ADDENDUM #2

PROJECT #: 43188
PROJECT TITLE: Franklin 6th Street Resurfacing
CLIENT: City of Franklin, Ohio
Issue Date: August 7, 2026

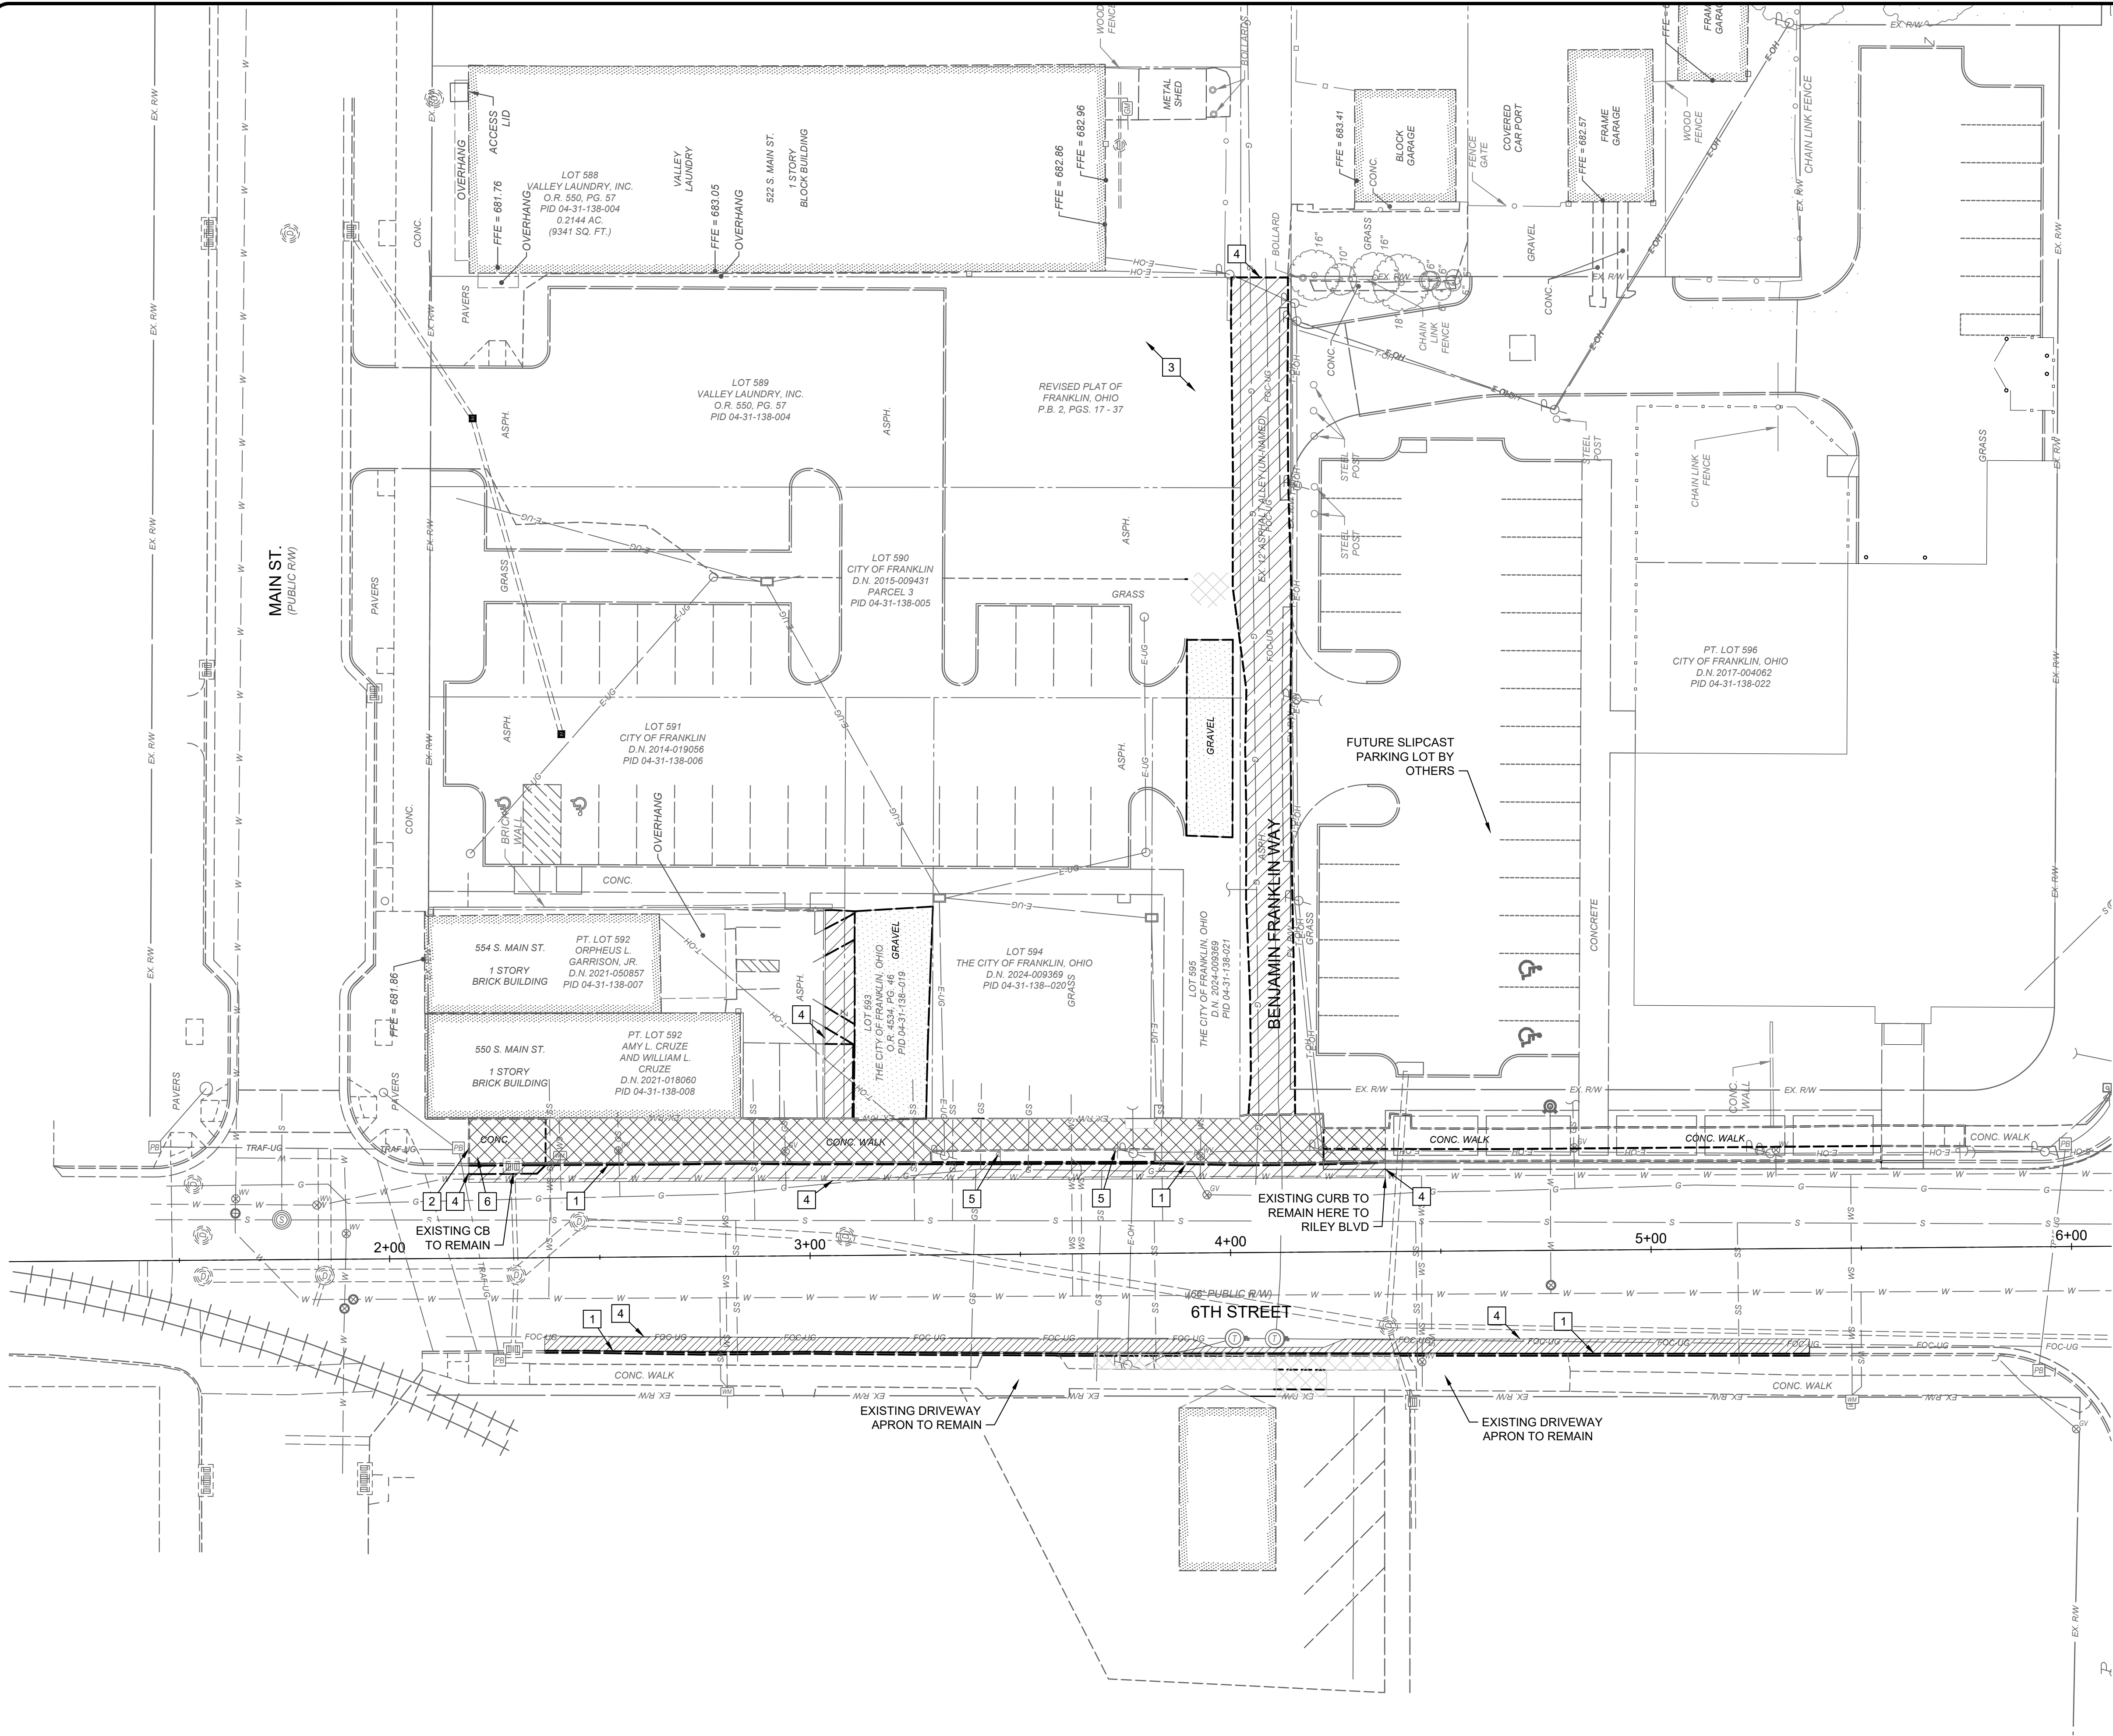
- 1) During the preconstruction meeting, it was incorrectly stated that no pavers would be installed adjacent to the building at 550 S. Main Street. The sidewalk shall follow the pattern shown in the contract documents. An example of the proposed pattern can be seen along 4th Street, which was constructed as part of the previous streetscape project.
- 2) Item 301 is incidental to the pavement repair item 253 and the pavement repair item is now only included with Alt 1.
- 3) Item 301 is also incidental in the item 448 Full Depth Alley Pavement.
- 4) In alternate 2, item 301 is a stand-alone pay item for the full depth pavement on 6th Street.
- 5) Q: Will a lighting foundation template be provided?
A: No template to be provided. Contractor may create own template if needed based on Plinth Details in Decorative Lighting Foundation.
